**MUDDY RUN II STREAM AND WETLAND RESTORATION  
PROJECT  
MONITORING REPORT  
MONITORING YEAR 4  
FINAL**

DUPLIN COUNTY, NORTH CAROLINA  
CONTRACT No. 004631 - PROJECT No. 95354

RE: Muddy Run II Stream and Wetland Restoration Site: MY4 Monitoring Report  
(NCDMS ID 95354)

Listed below are comments provided by DMS on January 17, 2018 regarding the Muddy Run II Stream and Wetland Restoration Site: Year 4 Monitoring Report and RES' responses.

Figure 3. Current Conditions Plan View Map (CCPV)

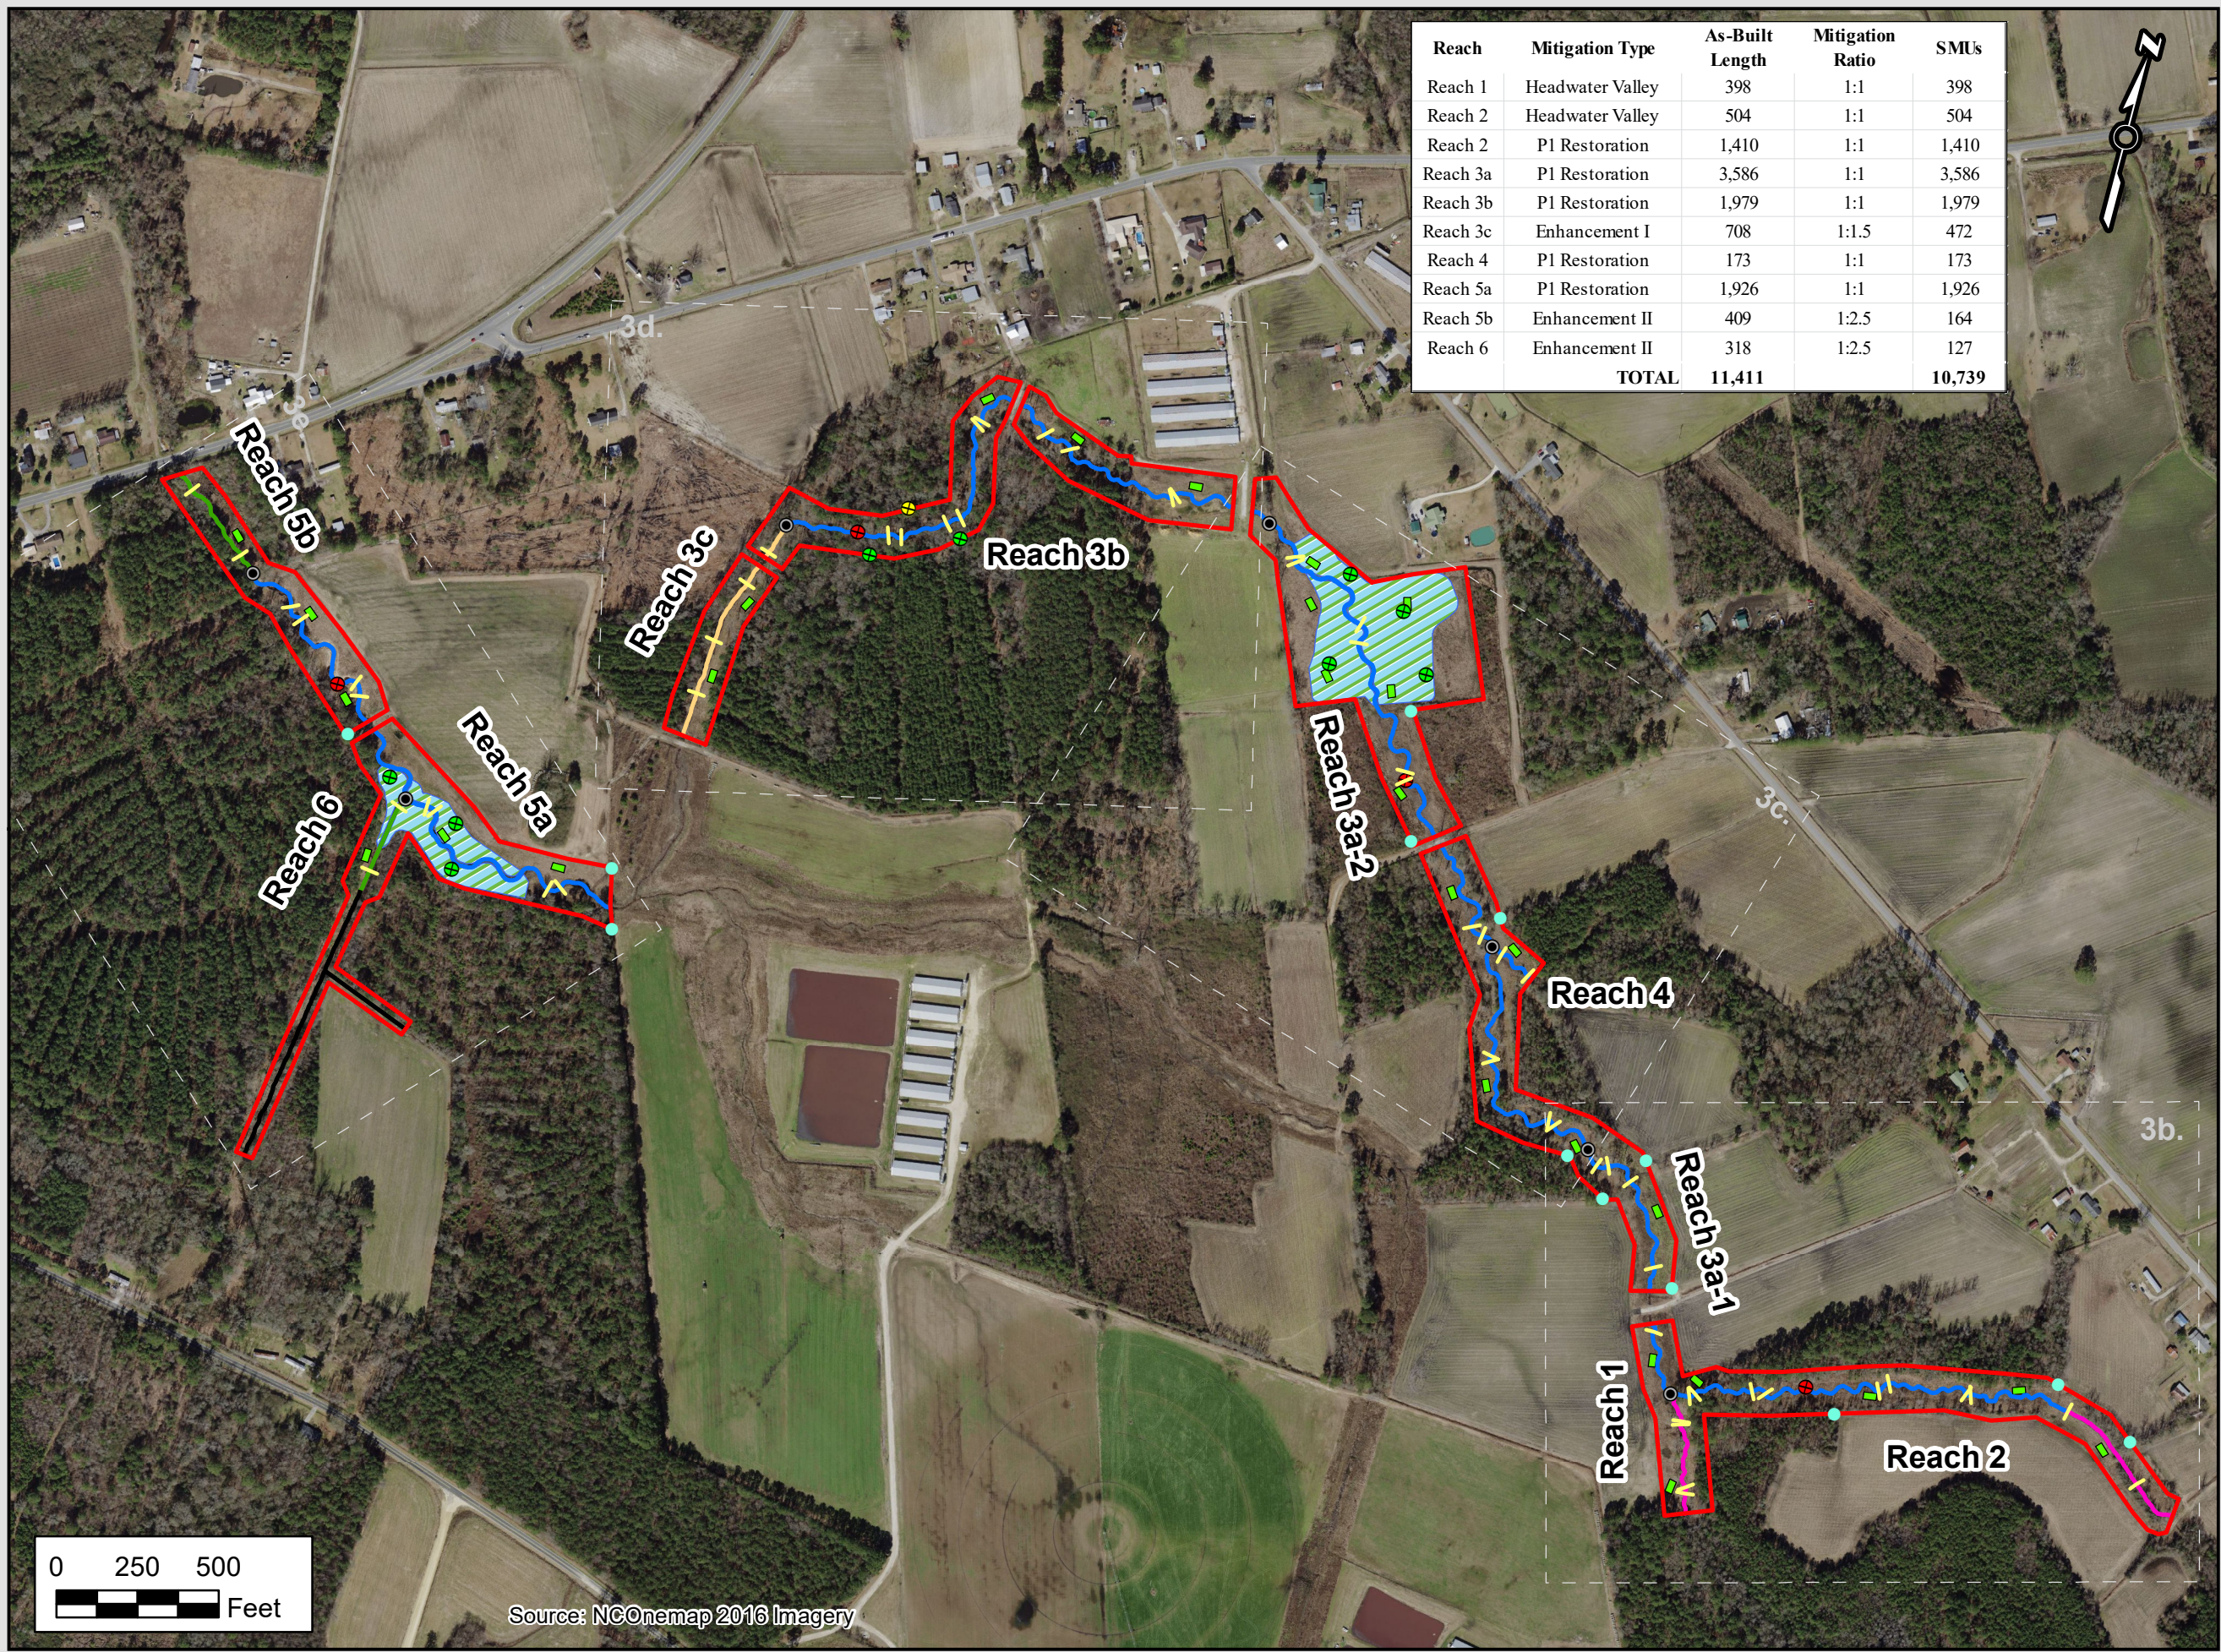
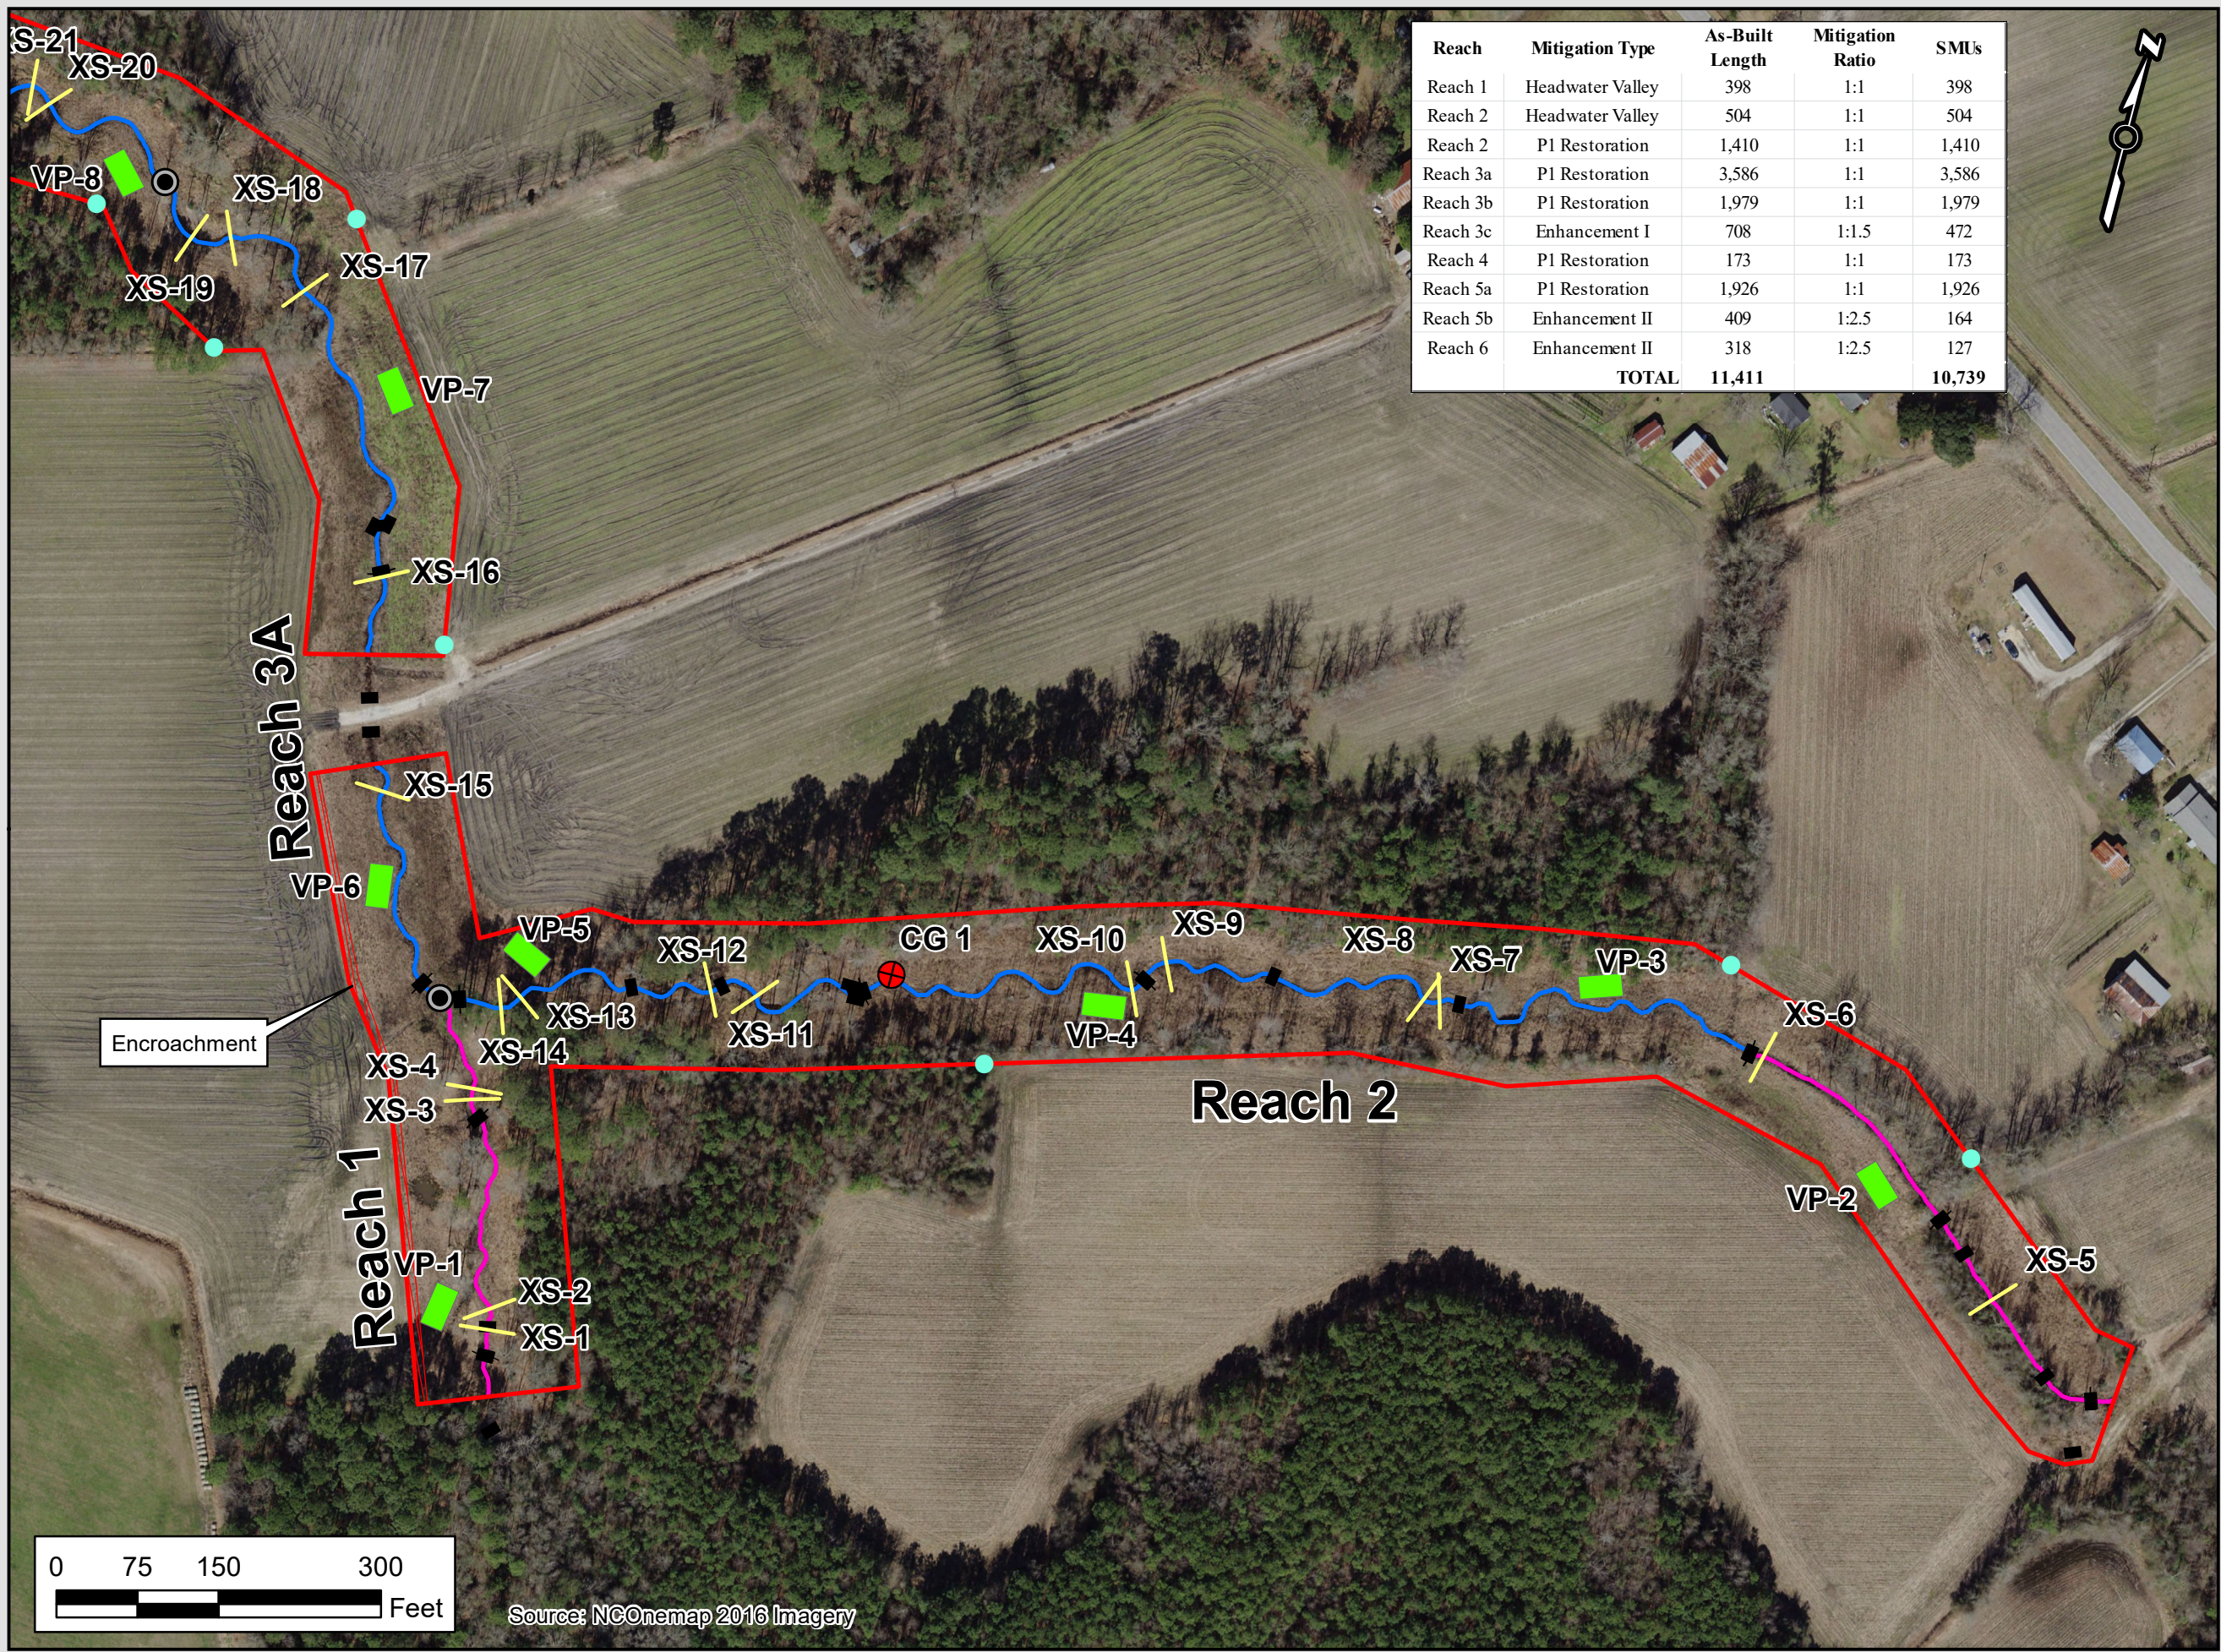
- b. Reach 6 credit: the map shows the upper portion of reach 6 as having EII credit, but the Mitigation plan shows this as a non-credit area. I think you could list the upper portion of this reach and the side channel as additional stream, not for credit. Please update CCPV.

The upper portion of Reach 6 (893 ft) and the side channel (307 ft) that confluences with it are now shown as “Channel – No Credit” on the CCPV and a footnote about them has been added to Table 1. Reach 6 is also discussed in Section 1.3.1.
